Design Commission Hearing Topic

PROJECT SUMMARY

The proposed development is for a 15-story multi-family apartment building located at the southwest corner of NE 7th Avenue and NE Oregon Street in the Lloyd District. Tax lot 1N1E35BC2200 is currently occupied by an office building. Tax lot 1N1E35BC2100 is vacant.

Landscape and Tree Plan Ground Level

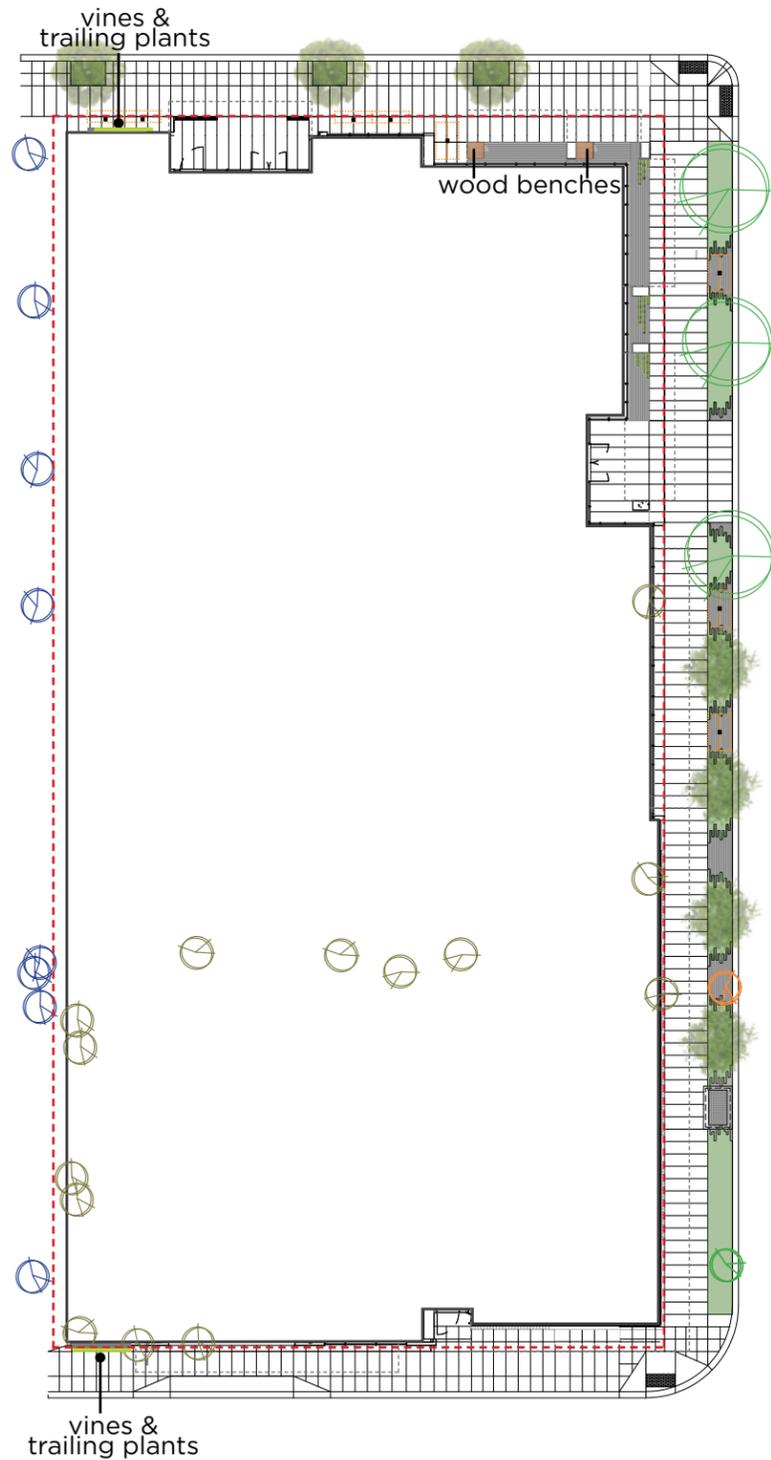
7. Likely success of landscaping in the above-ground planters, including the viability of vines growing up the wall

- Commissioners would like additional information on landscape planter design and on freeze protection/maintenance regimes for irrigation maintenance.

- Sheet C.25-B provides additional detail on the ground-level landscape planters, which will be installed at sidewalk level due to insufficient depth from grade to the top of building foundation below.

- The raised planters will provide sufficient growing medium, insulation to modulate soil temperature, and irrigation for the vines.
- Star jasmine vines are capable of twining up the provided cables.

- Drip irrigation tubing will utilize adequate cover to minimize the threat of freezing.

Rendering NE Corner

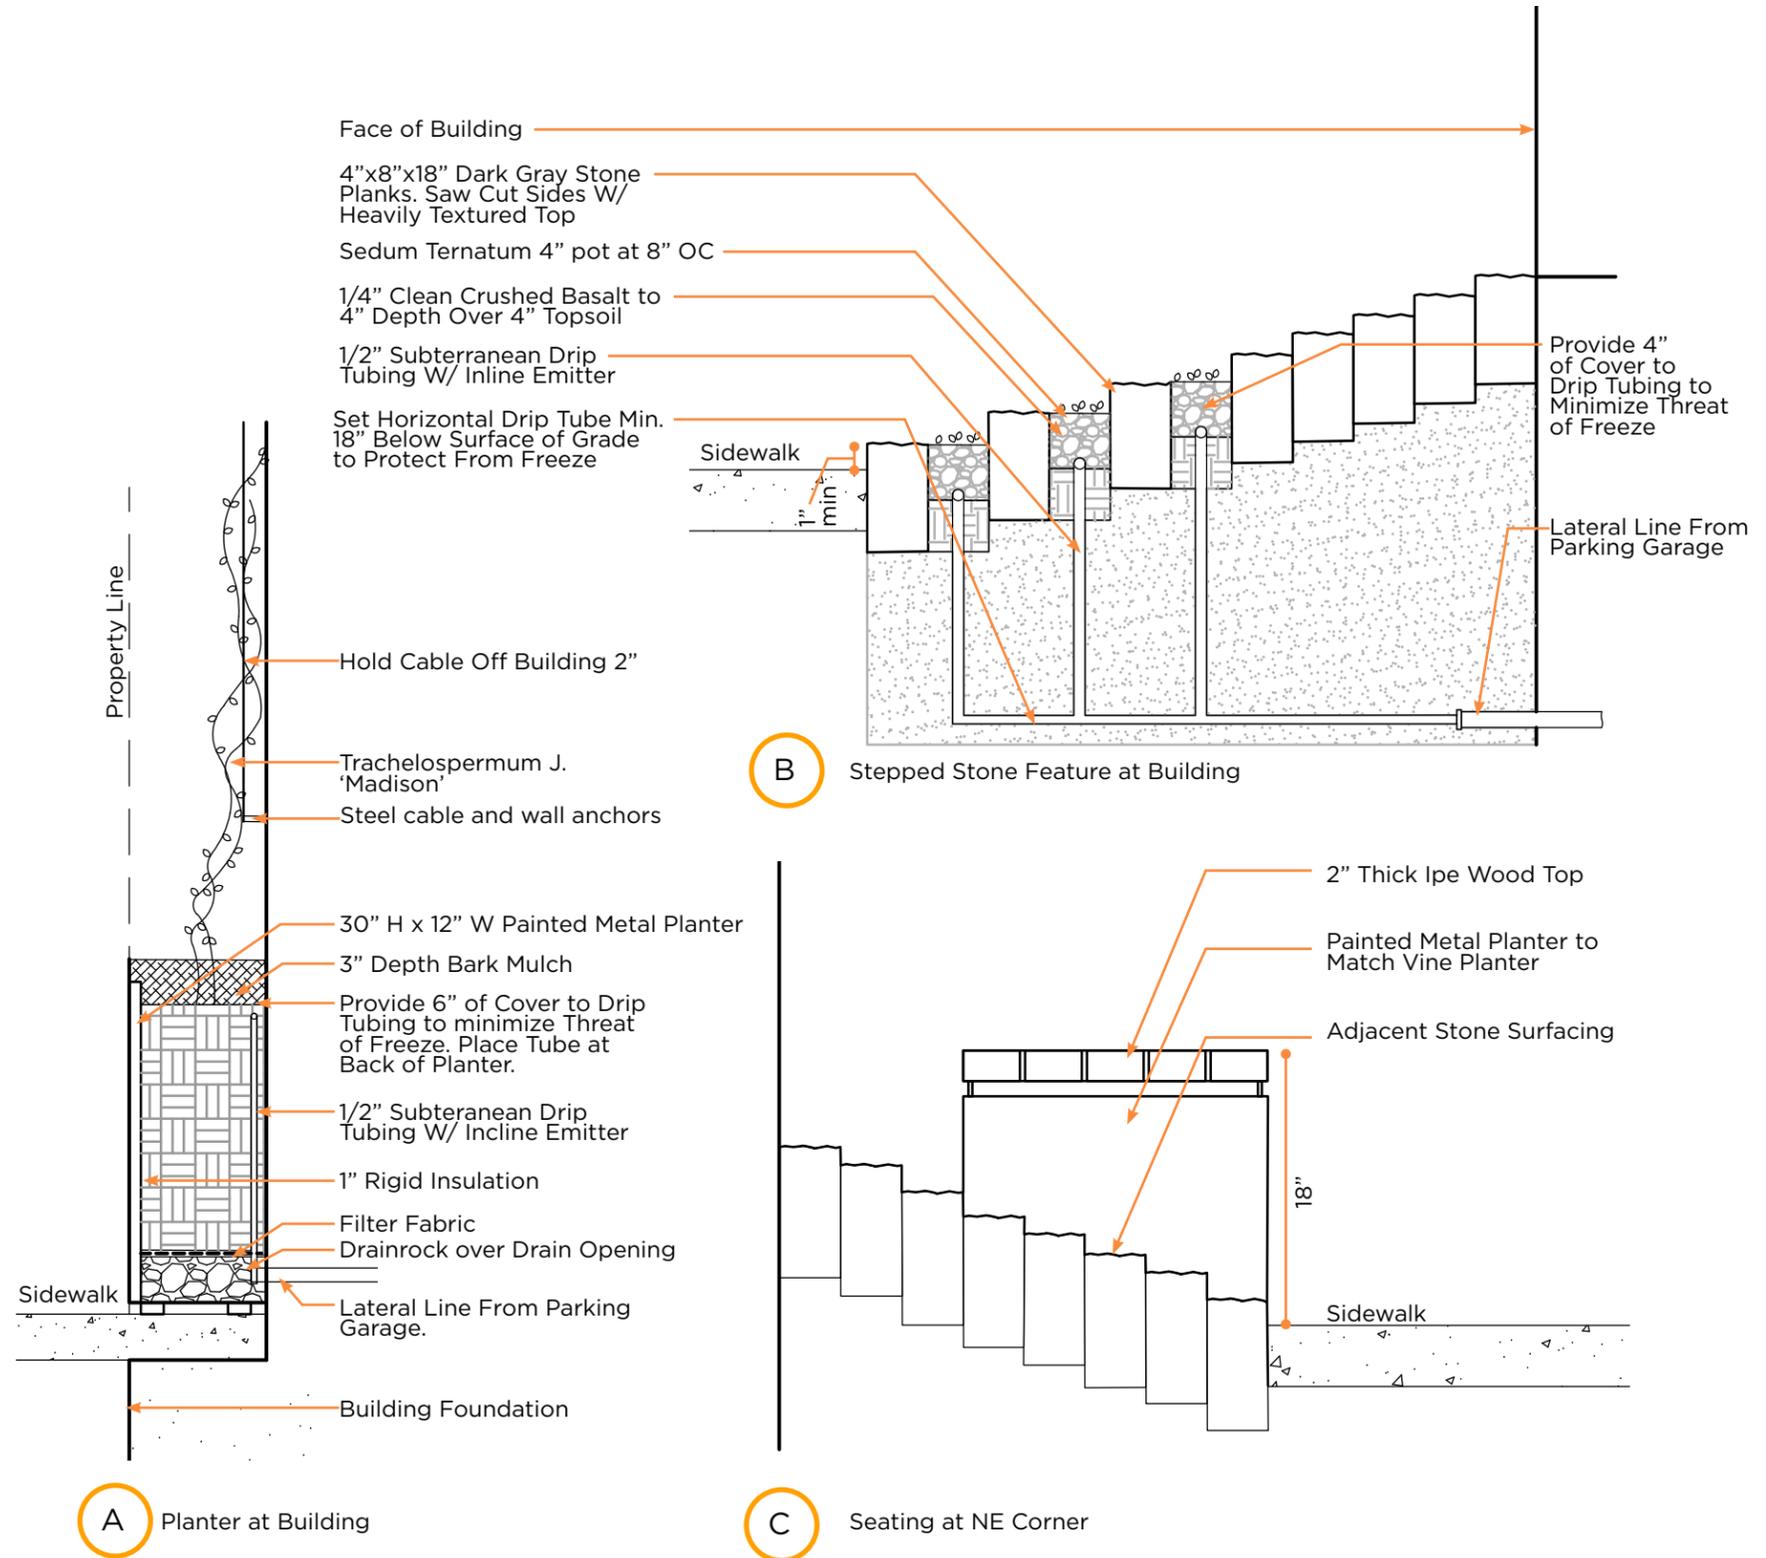
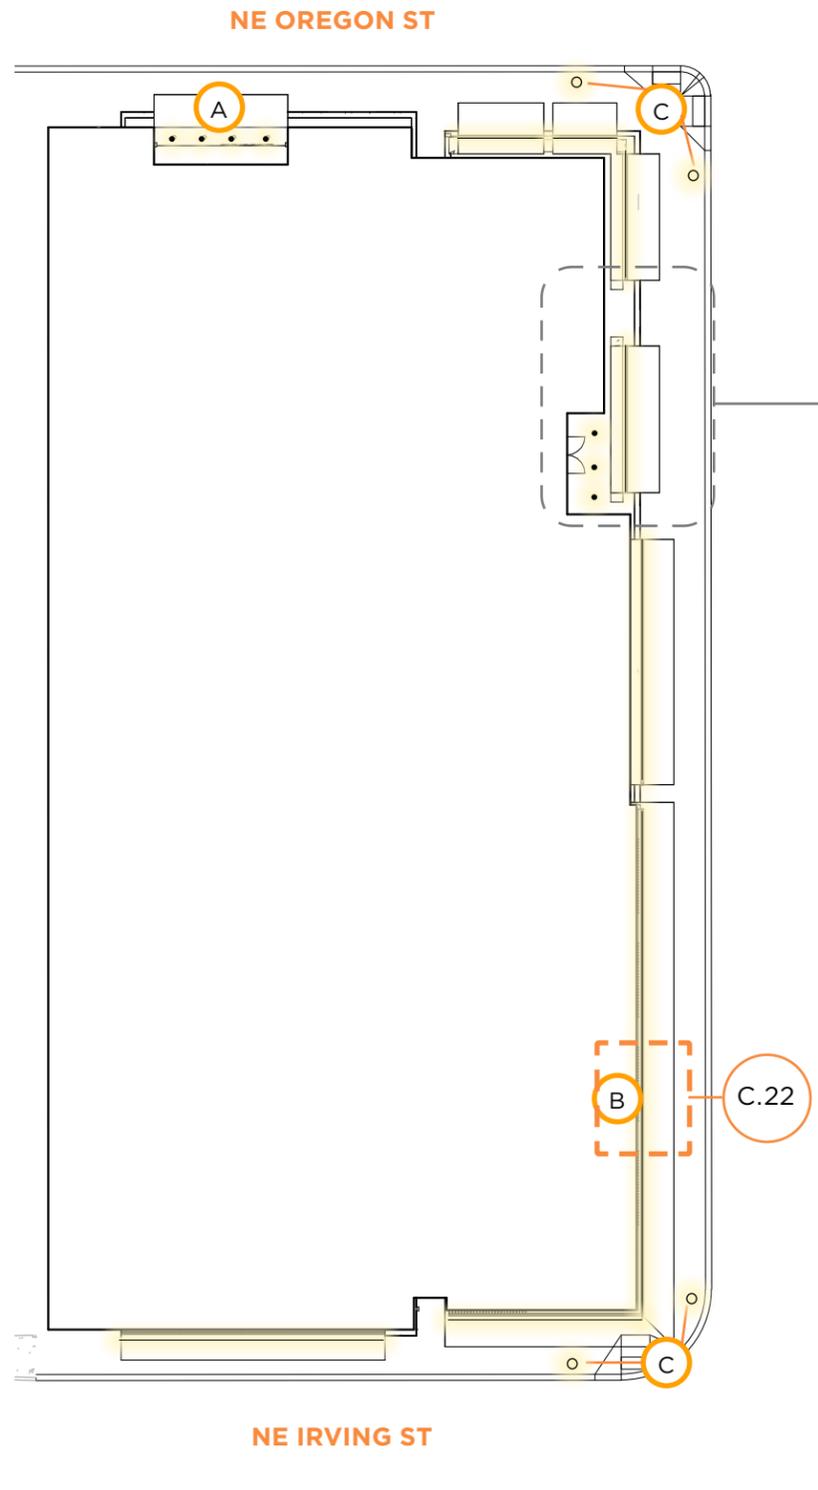
8. Details of the northeast corner seating element and likely success of the covered sedums

- The Design Commission concluded this was satisfied.
- Commissioners would like additional information on landscape planter design and on freeze protection/maintenance regimes for irrigation maintenance.
- Commissioners would like 3D views of the Green Loop experience from the sidewalk, extending from the public art feature northward and around the corner to the benches.

- Mackenzie landscape architects propose sedum ternatum due to its hardiness (Sheets C.25 and C.25-B). The plants will be irrigated and health will be monitored so replacements can be installed if dieback occurs.
- Sheet C.25-B provides additional detail on the sedums and the benches.
- The stepped stone feature will provide sufficient growing medium, insulation to modulate soil temperature, and irrigation for the sedums (Sheet C.25-B).
- Drip irrigation tubing will utilize adequate cover to minimize the threat of freezing.
- Renderings of sidewalk-level views of the NE 7th Ave alignment of the Green Loop have been provided on Sheets C.25 and C.25-B.

The vines will be planted in an above-ground metal planter due to the building foundation below grade. To keep the planter within the property line, the maximum width of the planter is 12". The planters will accommodate a soil volume of 24" depth x 10.5" wide of soil. Vines have the capability of growing in thin profiles such as this and reaching heights of up to 40'. The best vine for this application is the star jasmine vine. This vine is valued for its evergreen appearance, fragrant flowers and twining capability, as opposed to suckering. This vine is grown throughout Portland and can be found on the east side of the Hyatt House on S Moody Ave (see Detail I on C.18) and at the AIA Center for Architecture in the Pearl District. The plant does well in all light exposures and is preferred over other potential vine options.

To moderate the soil temperature on the southern planter, one inch of rigid insulation will be used to insulate the soil from the wall and three inches of mulch will be used on top of the soil. The vines will be irrigated with subterranean drip tubing.

Sedums are known to be hardy and durable plants. When broken they have the ability to re-seed themselves. Sedums endure long periods of drought, grow in porous, rocky soil and have minimal water requirements. Sedum ternatum is proposed for its ability to grow in shadier conditions than other sedum species. Since the sedums are under the canopy, irrigation will be provided via underground drip tubing.

Legend: Window Pattern Organization

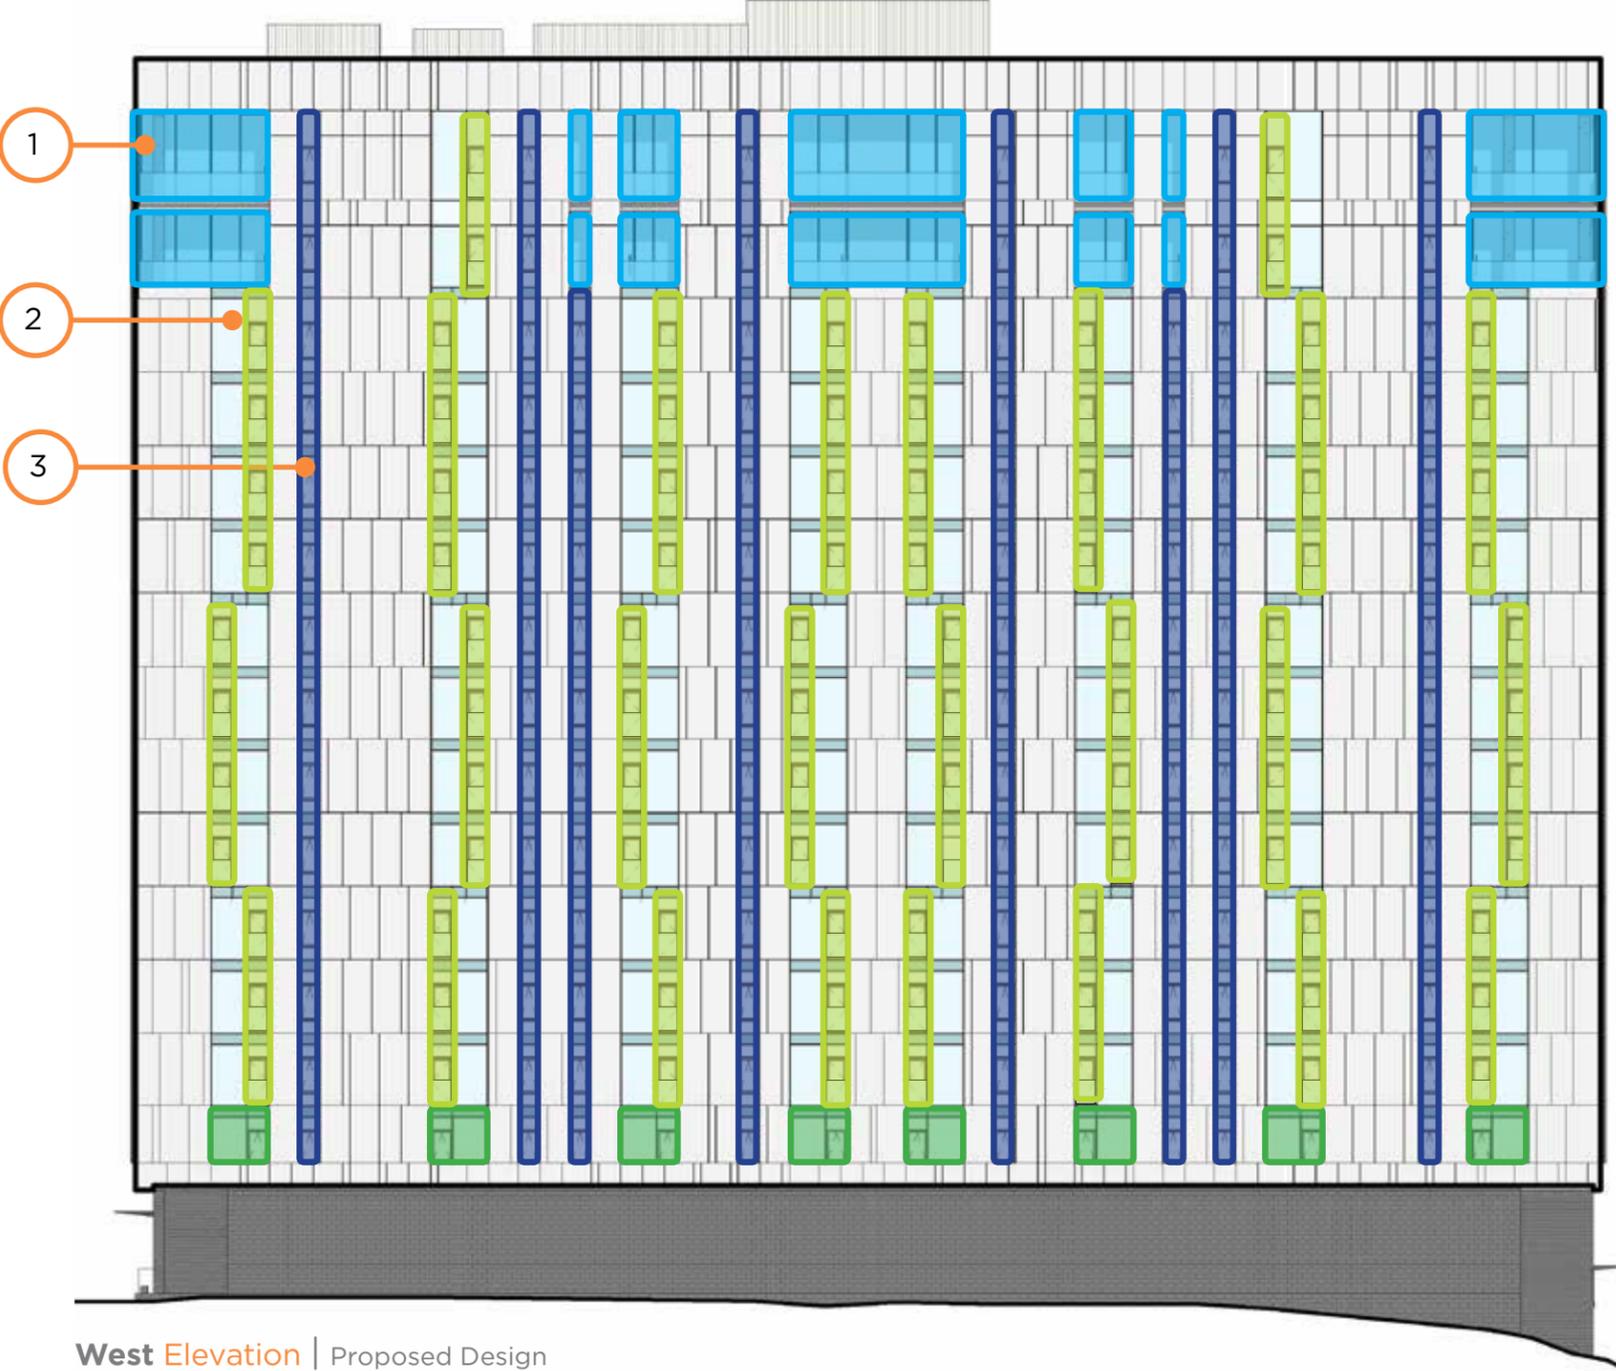
6. Lack of proposed balconies

- The canopy needs to complement the art/water feature.
- The Design Commission requested additional balconies on the east façade to communicate the residential character of the building. Commissioners suggested considering a vertical strip of balconies at the southeast corner.

- The applicant has added a significant number of balconies on all 4 elevations. The original design included 15 recessed balconies. Based on the Design Commission’s input the design now includes 39 recessed balconies and 184 Juliet balconies for a total of 223 (Sheet APP.11-B).

- Living Windows
- Bedroom Windows
- Recessed Balconies (39 total)
- Juliet Balconies (184 total)

- 1 Recessed balconies are incorporated at the larger units on the upper levels to provide a clear and distinctive character for the buildings top floors where views are meaningful and noise from I-84 less impactful.
- 2 Living spaces are consistently articulated by large 8ft-wide, floor-to-ceiling windows with Juliet Balconies that are vertically aligned at the exterior elevations to provide natural light and views
- 3 Bedrooms are consistently articulated by large 3ft-wide, floor-to-ceiling windows that are vertically aligned at the exterior elevations to allow for a balance of daylight and privacy.
